# 50GBASE-FR and 100GBASE-DR, ER and MPI (Comment 138, 139) (200GBASE-DR4 and 400GBASE-DR4)

IEEE P802.3cd, March 2017, Vancouver  
Jonathan King, Finisar

# MPI penalty vs ER (3 dB IL, 4x45 dB RL)

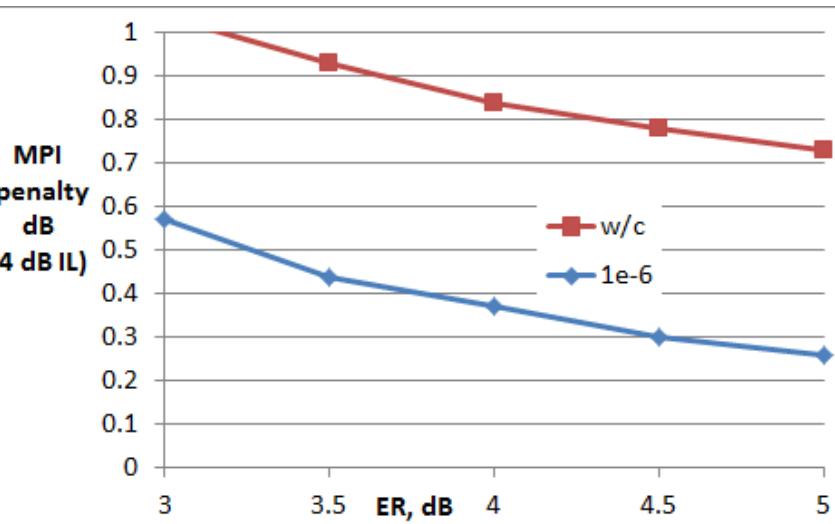
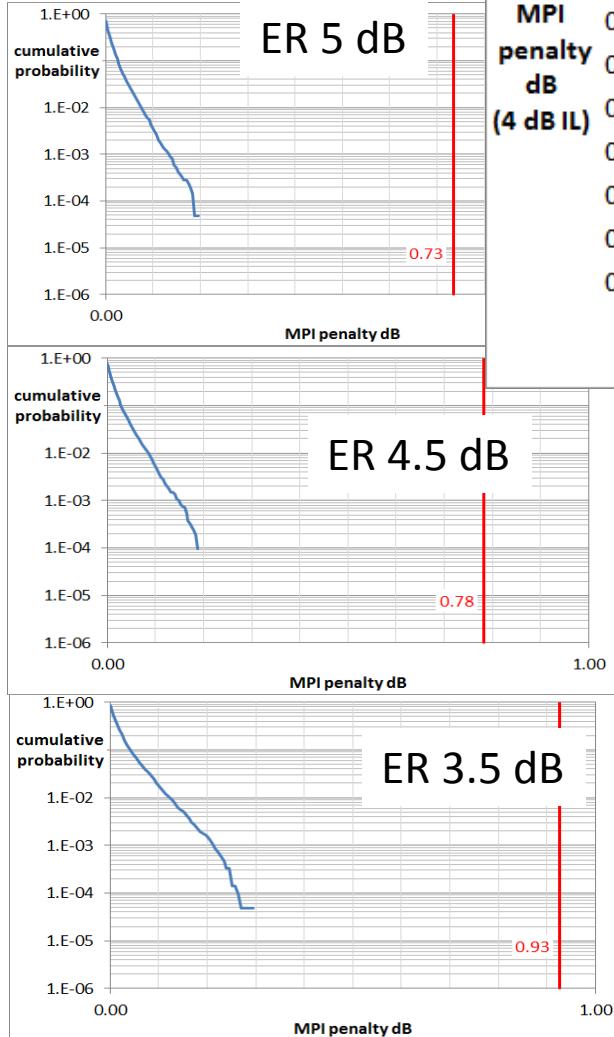
**MPI penalty  
increase is 0.03 dB  
for ER = 3.5 dB  
(from ER = 5 dB)**

- In section 139.6.1, Table 136-6 reduce minimum ER to 3.5 dB
- In section 140.6.1, Table 140-6 reduce minimum ER to 3.5 dB
- No changes to the 'Average launch power, max' or 'Average received power, max' specs

# MPI penalty vs ER (4 dB IL, 4x35 dB RL)

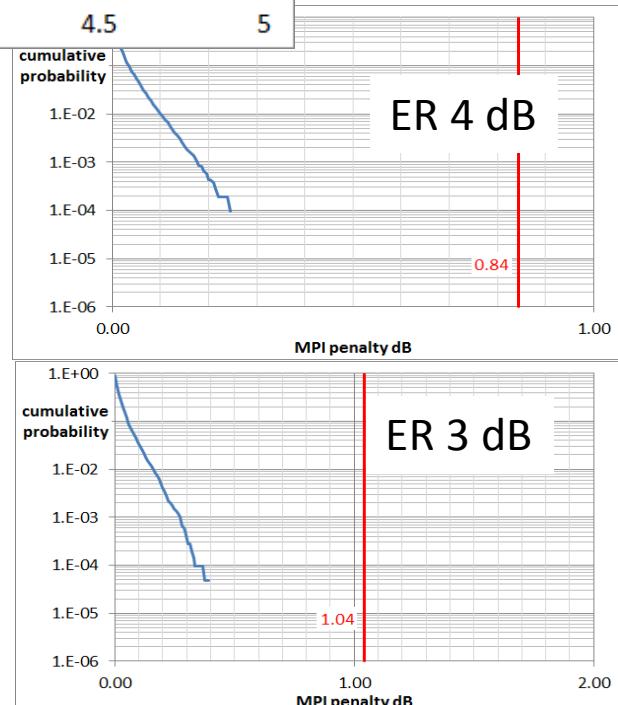
**MPI penalty  
increase is 0.12 dB  
for ER = 3.5 dB  
(from ER = 4.5 dB)**
